<h2>Product/Process Change Notice (PCN)</h2>																															
<input checked="" type="checkbox"/> Major Change <input type="checkbox"/> Minor Change																															
<b>PCN Number:</b> PCN_FrqSPXO_20250213  <b>Affected Series:</b> WE-SPXO  <b>Affected Part Number:</b> See table below  <b>PCN Date:</b> 2024-11-13 (YYYY-MM-DD) <b>Effective Date:</b> 2025-02-13 (YYYY-MM-DD)	<b>Change Category:</b> <input type="checkbox"/> Equipment/Location <input checked="" type="checkbox"/> General Data <input type="checkbox"/> Material <input type="checkbox"/> Process <input type="checkbox"/> Product Design <input type="checkbox"/> Shipping/Packaging <input type="checkbox"/> Supplier <input type="checkbox"/> Software																														
<b>Contact:</b> Product Management  <b>Phone:</b> +49 (0) 7942 - 945 5001  <b>Fax:</b> +49 (0) 7942 - 945 5179  <b>E-Mail:</b> pcn.eisos@we-online.com	<b>Datasheet Change:</b> <input checked="" type="checkbox"/> Yes <input type="checkbox"/> No  <b>Attachment:</b> <input type="checkbox"/> Yes <input checked="" type="checkbox"/> No

3. Correction of the Product Dimensions:

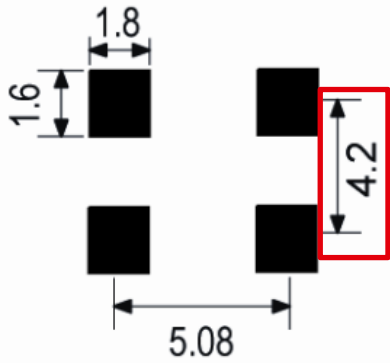
Before	After
Product Dimensions		
L	7.2 max	7.0 ± 0.2
W	5.2 max	5.0 ± 0.2
H	1.4 max	1.8 max

4. Correction of the Solder Pad Layout:

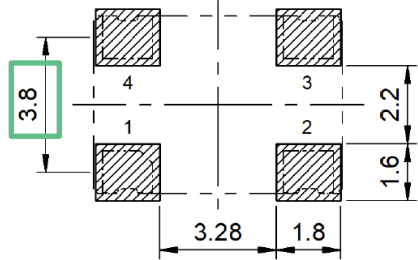
Before	After
Solder Pad Layout
